#### British Gliding Association - Technical Committee

#### **Technical News Sheet 02/02**

Service Bulletin 336-10

Cockpit Controls - rear control stick

picture 1: rear control stick

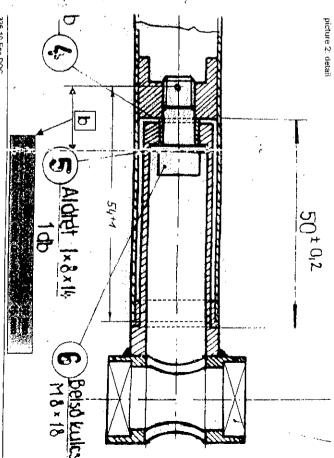
DIN 912-8.8 failed between both parts of the control stick - controlability of the and lower part of the rear control stick. If connection by socket head screw M8x18 of following picture 1) was broken. These socket head screw connects upper-A Routine check has showed, that socket head screw M8x18 DIN 912-8.8(part 6 glider is endangered.

screw was drilled additional 2x at same distance to the screw head 90° misplaced improperty at a wrong position (see position 8 of following picture 1). Socket head (arnothing 3mm and arnothing 2mm). Through that the pretended cross-section of the thread At the affected glider the socket head screw M8x18 DIN 912-8.8 was drilled was important lessened

- Remove the rear control stick
- Remove part 1 (see picture 1)from the control stick; for this remove split (part 6, picture 1). After this pull out part 1 from control stick pin (part 8, picture 1) and remove socket head screw M8x18 DIN 912-8.8

- ω Check for correct drilled split pin hole in the control stick and the socket head screw like picture 1 and 2.
- secure with a splint pin and install the completed control stick in the rear If splint pin hole is drilled correct, installation of part 1 into the control stick,

- Ö control stick must be closed by WIG-welding from a certified WIG-welder. If splint pin hole is not drilled correct after picture 1 and 2, holes in the screw M8x18-8.8 DIN 912; lubricate brass buchings. Drill splint pin hole After that holes must be drilled after picture 1 and 2. Renew socket head (Ø 2mm) only if controlstick is completed and install the splint pin. Take care that part 1 rotates easy in the control stick
